World Forum for Harmonization of Vehicle Regulations

Proposal for 09 series of amendments to UN Regulation No. 16 (Safety-belts)

Submitted by the Working Party on Passive Safety *

"Annex 2

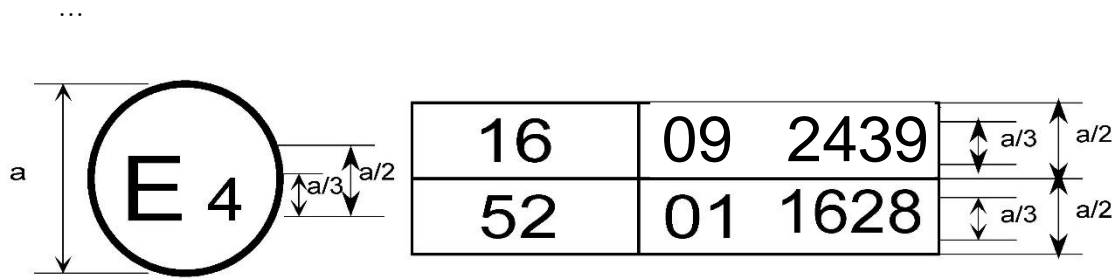
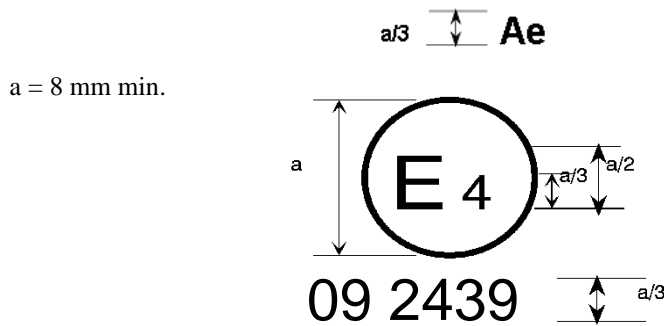
Annex 2, amend to read:

The above ... amended by the 09 series of amendments.

The above ... included the 09 series of amendments and Regulation No. 52 the 01 series of amendments.

2. Arrangements of the safety-belt approval marks (see paragraph 5.3.5. of this Regulation)

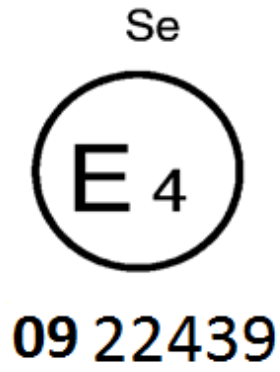
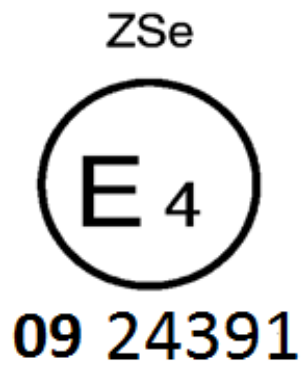
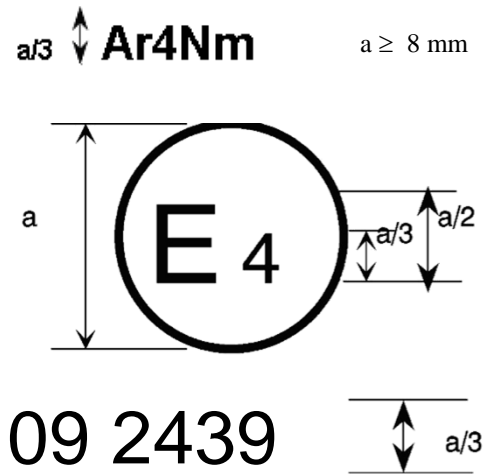
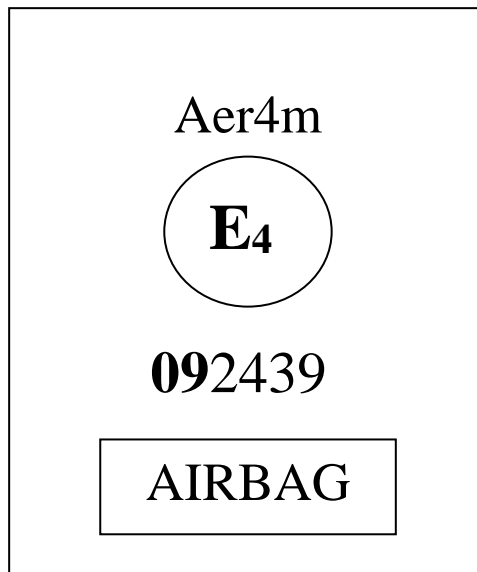
The belt ... the 06, 07, 08 or 09 series of amendments at the time of approval.

The belt ... 06, 07, 08 or 09 series of amendments at the time of approval.

The belt bearing ... the 06, 07, 08 or 09 series of amendments at the time of approval.

The belt ... the 06, 07, 08 or 09 series of amendments at the time of approval.

The belt ... the 06, 07, 08 or 09 series of amendments at the time of approval. This belt shall not be fitted to vehicles of category M₁.

The ... 06, 07, 08 or 09 series of amendments at the time of the approval. This safety-belt has to be fitted to a vehicle equipped with an airbag in the given seating position."
